Product / Process Change Notification

N° 2017-046-A

Introduction of an Additional Assembly and Test Location for TO220 Fullpak Narrow Lead products in Tianshui Huatian Microelectronics Co. LTD (TSHT), China for CoolMOS™ Products

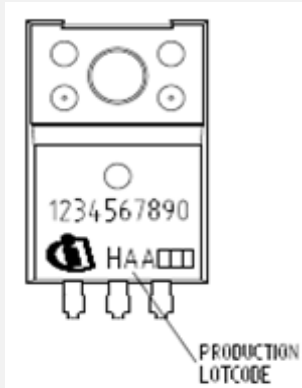
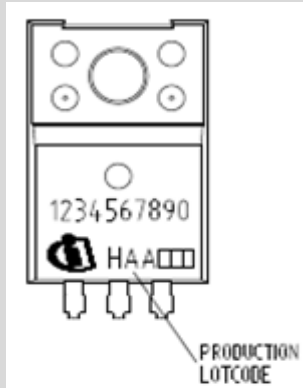
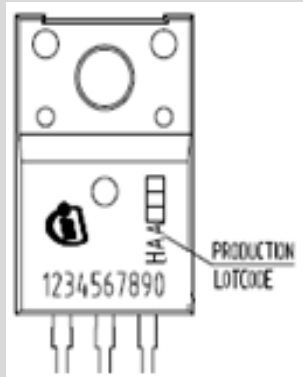
<u>Old</u>	<u>New</u>
<ul style="list-style-type: none"> Tongfu Microelectronic Co., Ltd. (TFME), China 	<ul style="list-style-type: none"> Tongfu Microelectronic Co., Ltd. (TFME), China Tianshui Huatian Microelectronics Co. LTD (TSHT), China
<ul style="list-style-type: none"> Package marking text placement for TFME 	<ul style="list-style-type: none"> Package marking text placement for TFME Package marking text placement for TSHT
